Product/ Process Change Notification								
1. PCN No.:	QPCN12012							
2. Subject:	TS34063 series wafer re-layout							
3. To:	All customers involved

4. Issued by:	Owen Wang							
5. Issue date:	12-Jul-2012							
6. Proposed first ship date for change:	12-Oct-2012							
7. Affected Product Identification								
TS34063 series (part no.: TS34063CD C3, TS34063CS RL)

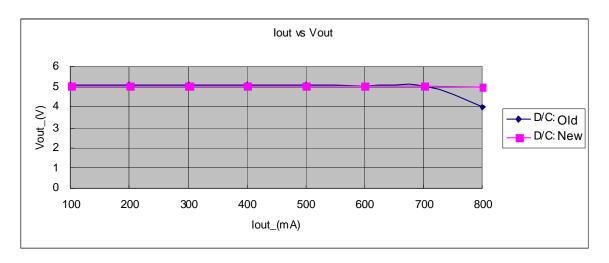
8. Change Description : (OLD Vs. NEW Cor	mparison)							
Old:	New:							
➤ Die size: 1.8 mm x 1.7 mm	➤ Die size: 0.93 mm x 0.73 mm							
> Old layout	New layout

14. Remarks								
The device circuit of new die is the same as old	d die. It's just re-layout for smaller die size.							
,								
15. Customer feedback required latest:	12-Aug-2012							
(should we receive no feedback; the change								
will be deemed as accepted!)	Ouguer Chan
